**Contract ID#: DC00344**

**WBS Element: 2022CPT.03.17.20652, 2022CPT.03.17.20101, 2022CPT.03.17.20102**

**County: New Hanover and Brunswick Counties**

**Subject: Addendum #1: DISTRICT 3 PAVEMENT PRESERVATION**

MAP NO. 2  
SR 1267 (WILDERNESS RD.)  
MP 0.28 - MP 0.43

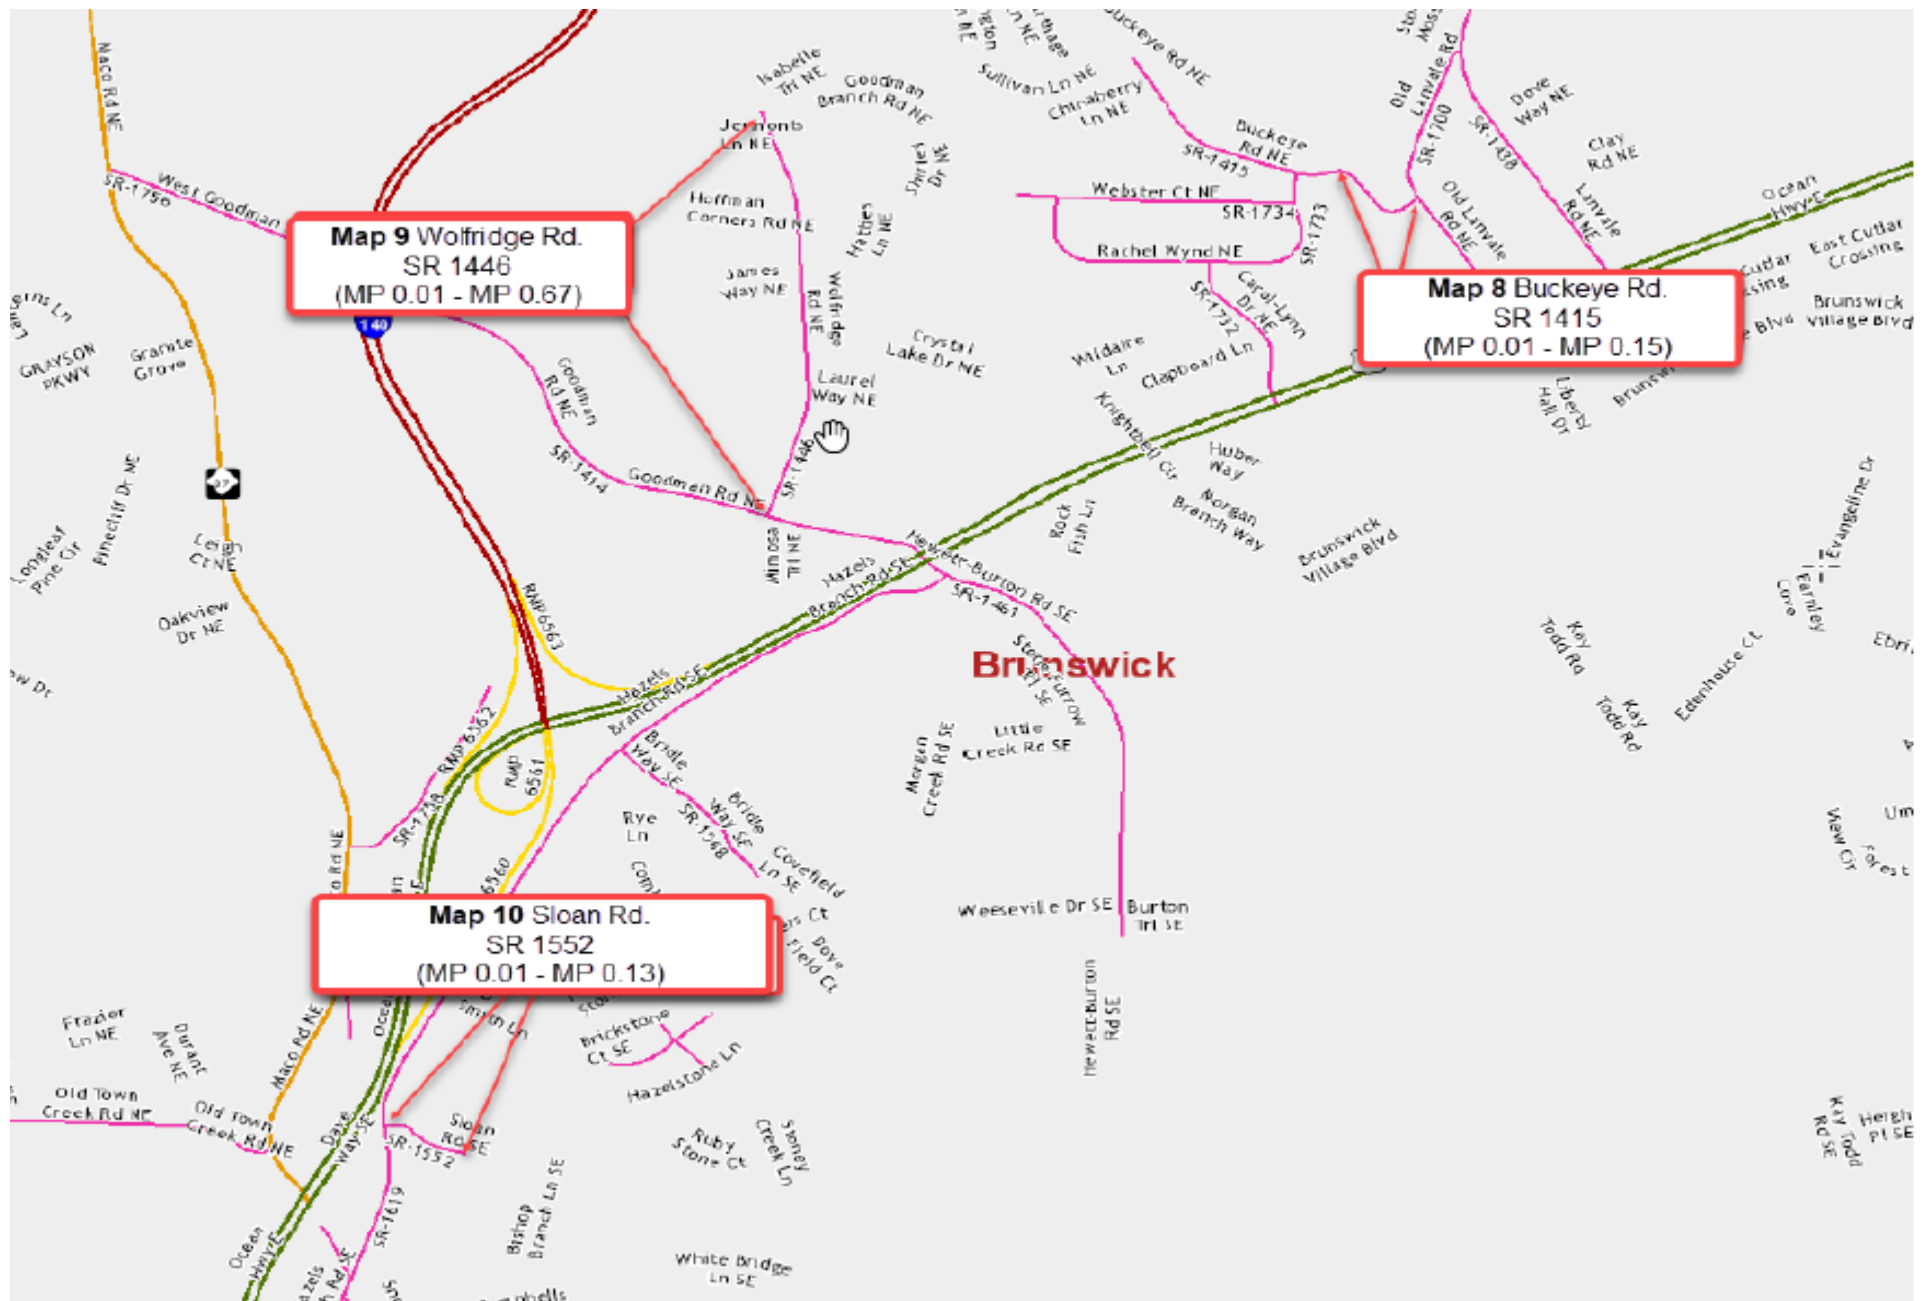
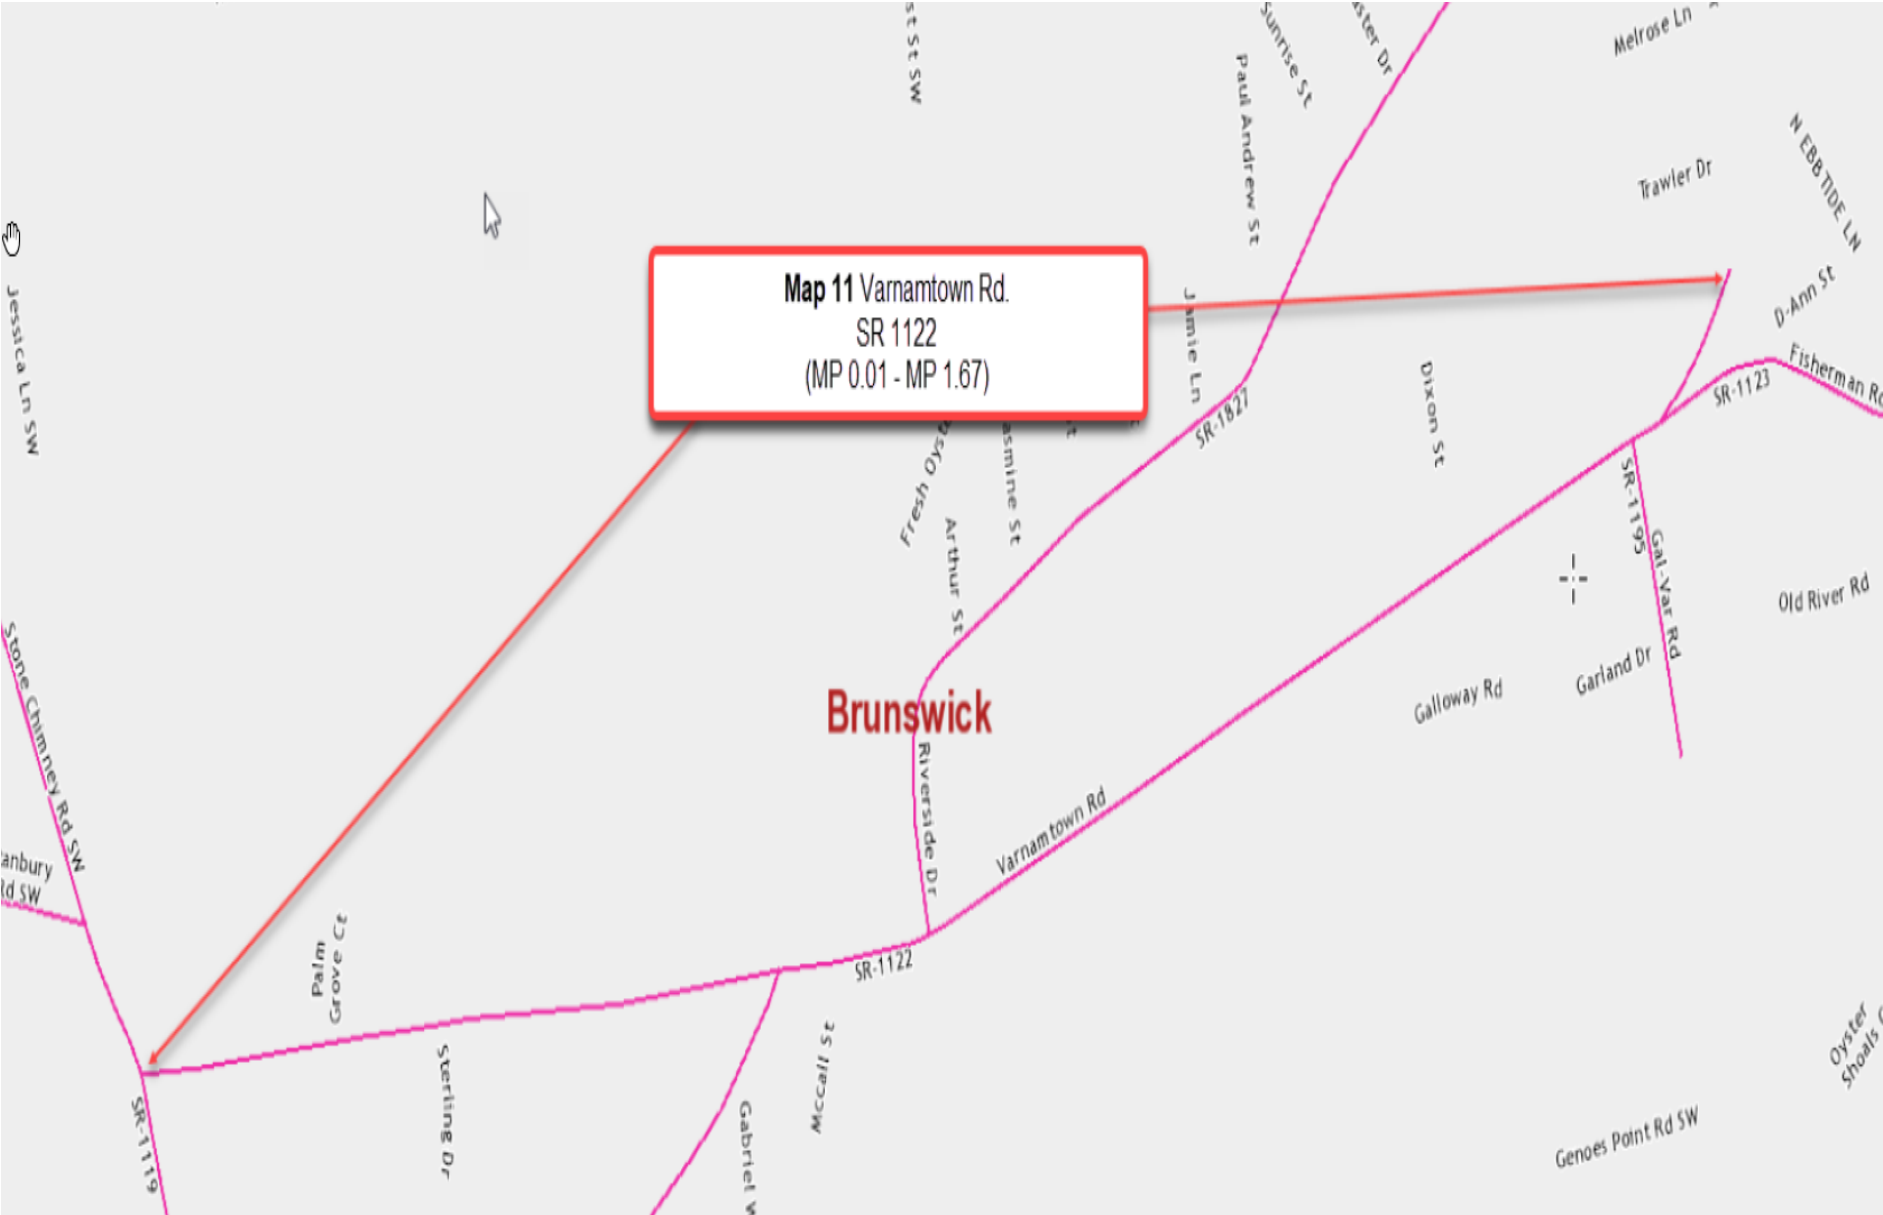
- 1- Project Plans (Plan Sheet No. 1, Map 2) has been revised in the *DC00344\_District 3 Preservation Plans*.
